Barlow Court
Barlow Road, Hudson, Ohio
Revised Submittal 8/3/21

Staff Comments and Email Follow-Up

July 28, 2021

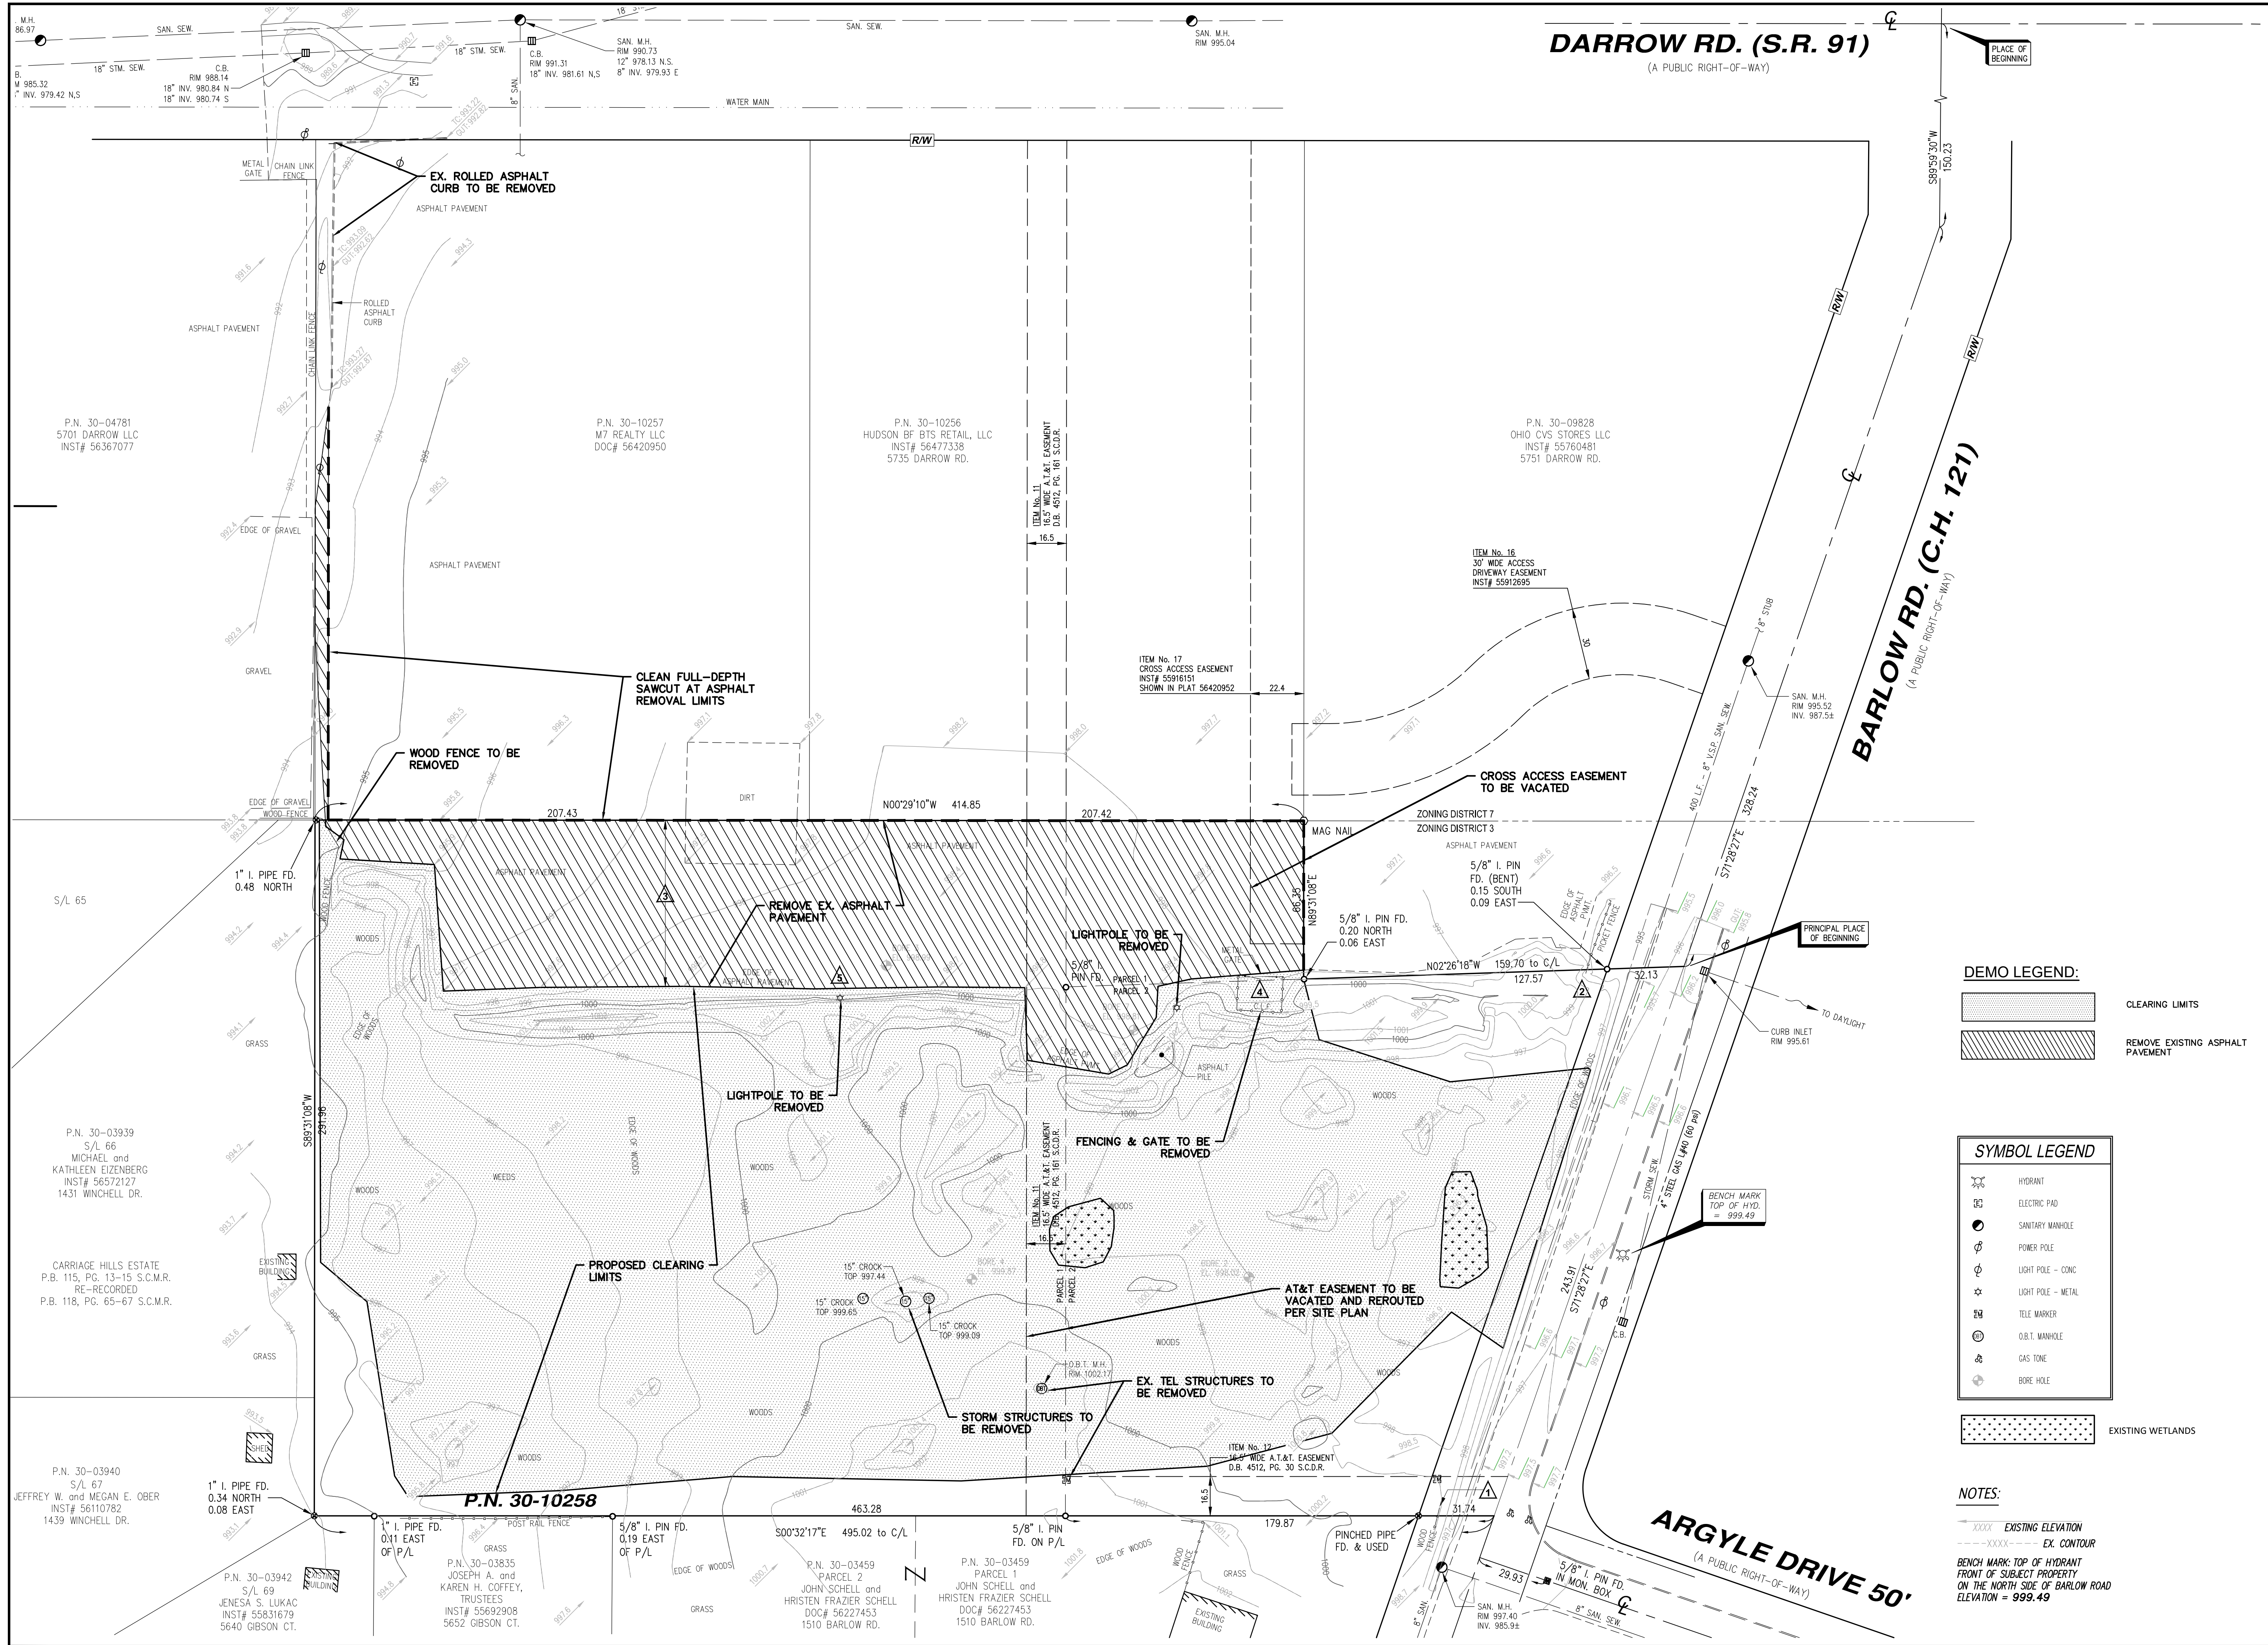
Open Space: Demonstrate compliance with the applicable open space standards.

Identify open space on site plan.

Was not shown on site plan. Would suggest providing a written statement that you would comply with the requirement for site plan review and would request funds-in-lieu for the public open space requirement.

10. The Planning Staff sought further information regarding Open Space. The Developer believes that the Plan reflects the required 25% of Open Space. However, the Developer agrees that the Plan will comply with the Open Space or cash-in-lieu requirements as part of the Site Plan Approval process.
